# CITY OF ALBUQUERQUE

**Re: Smiles for Kids Dental Office  
Conceptual DMP and Conceptual Grading Plan  
Engineer's Stamp Date -no stamp- (C12D054)**

Re: Smiles for Kids Dental Office, Hydrology Re-Submittal

SITE CONCEPTUAL DRAINAGE MANAGEMENT PLAN

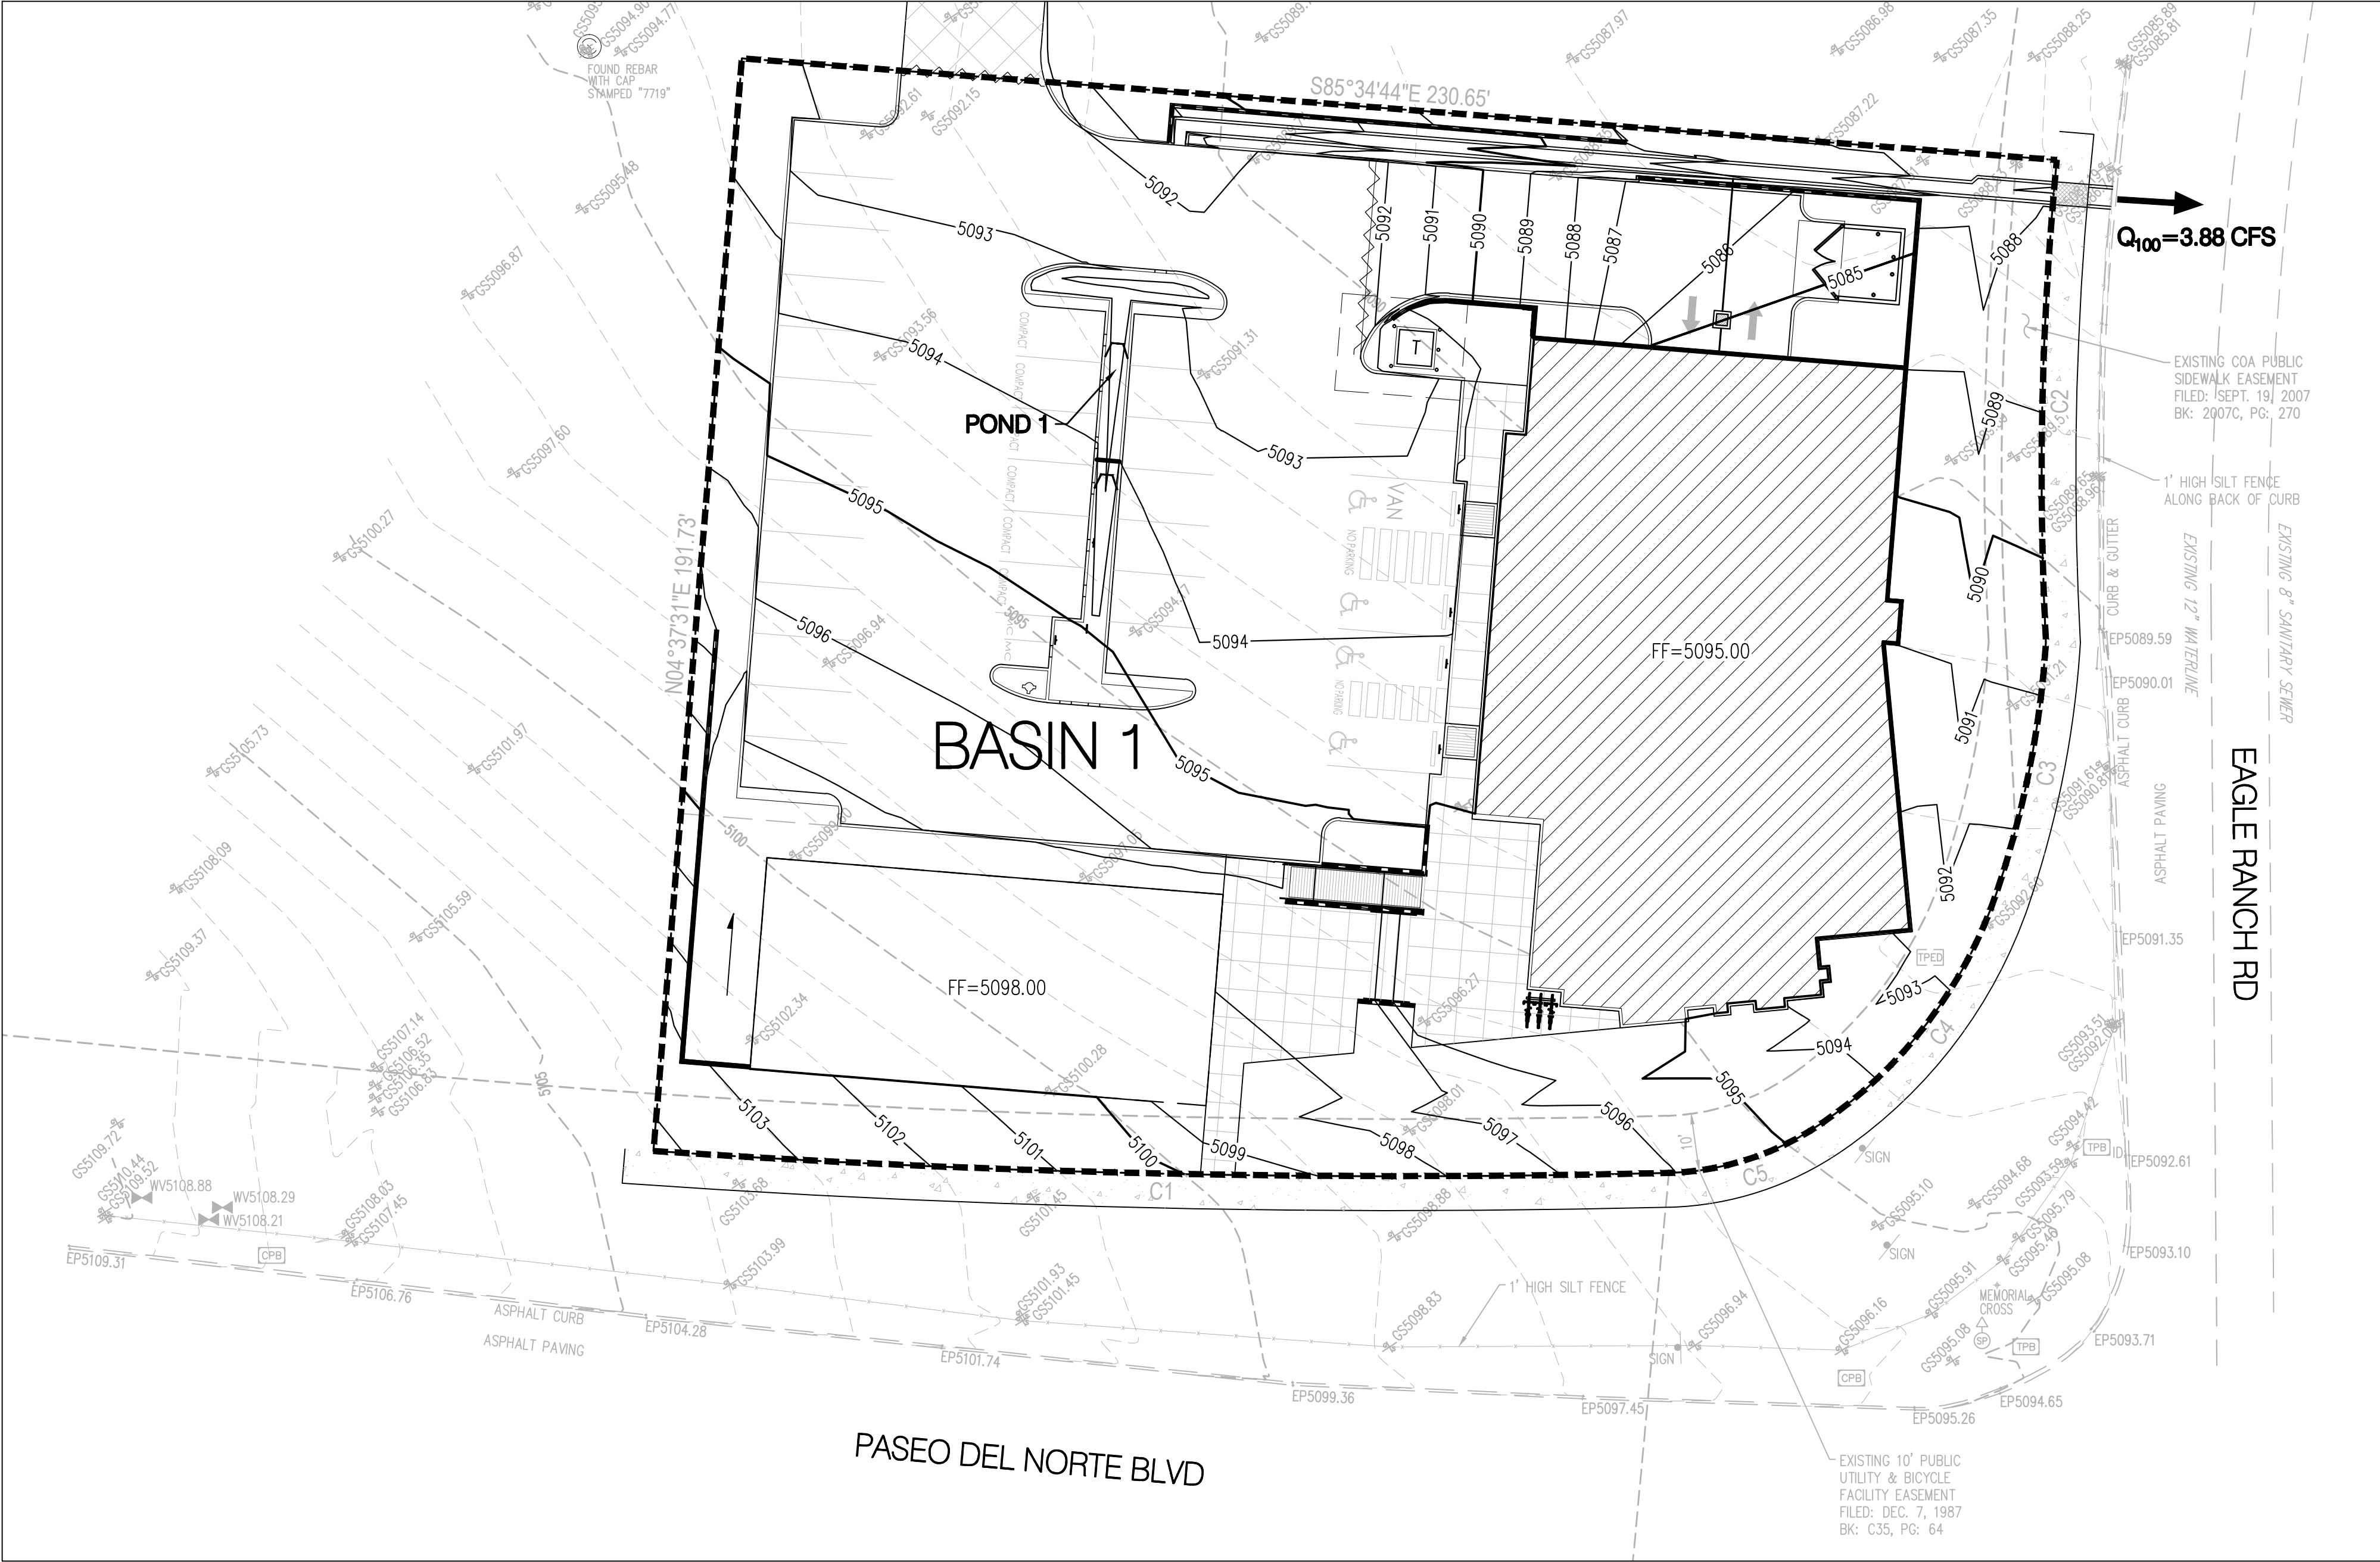
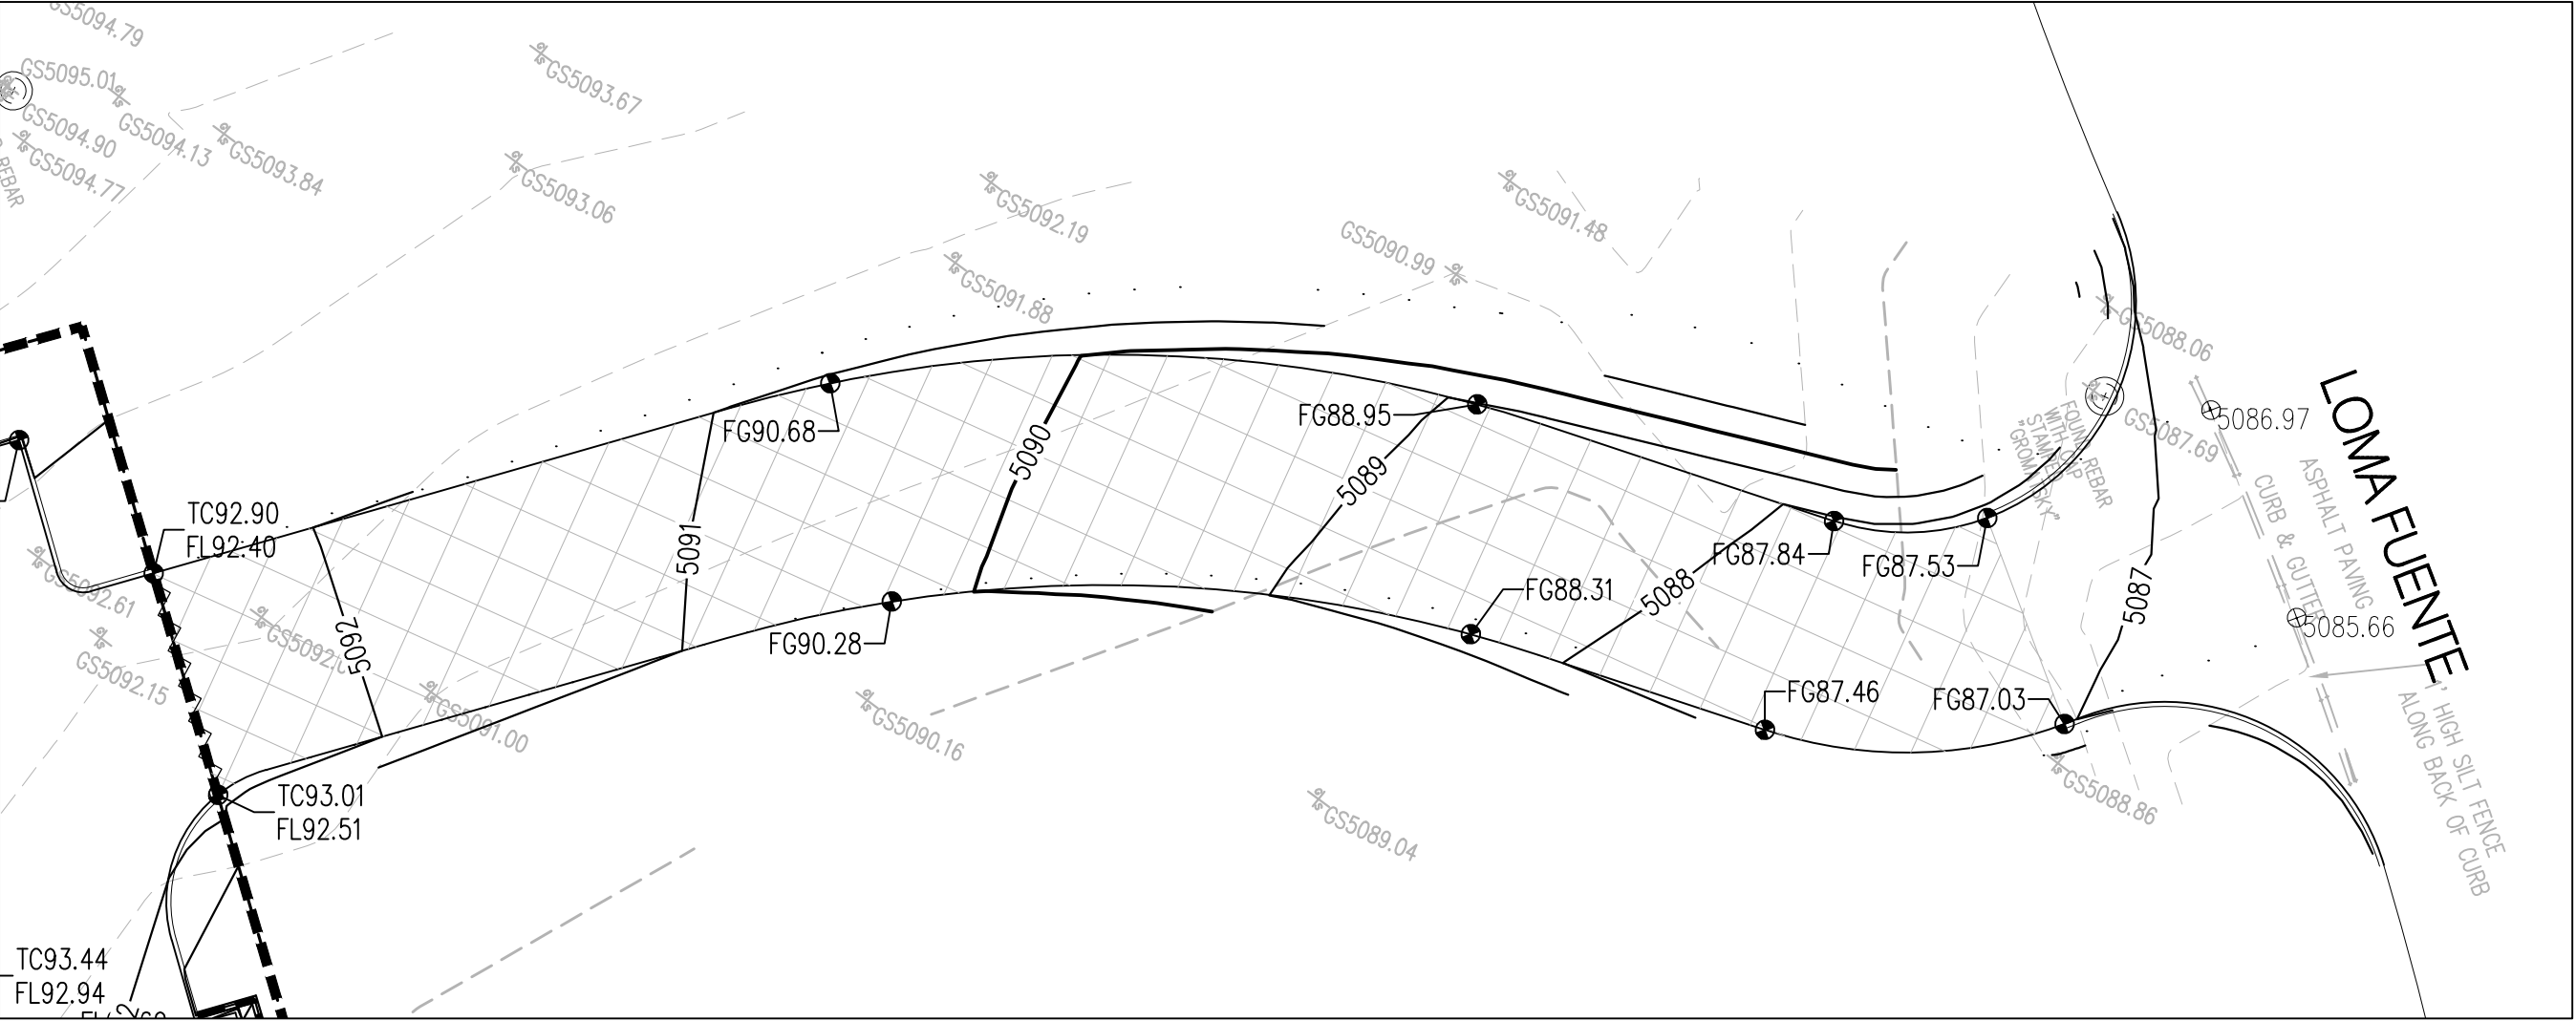
Based upon the information provided in your submittal received 2-17-15, the above referenced plans are approved for Site Plan for Building Permit action by the DRB with the condition that as access easement can be obtained across lot 10A1, which should be shown.

1. Provide the direction of roof flows.
2. Provide calculations for the channel and the sidewalk culvert.
3. Demonstrate, with a detail if necessary, how runoff from the landscape area on the east part of the site will enter the channel.
4. Explain why one building is hatched and the other is not.
5. Provided build notes for the curb cuts in the parking island that will receive the first flush.
6. Show curb, permanent or temporary, to be built on the access drive to Loma Fuente, at least on the downhill side.
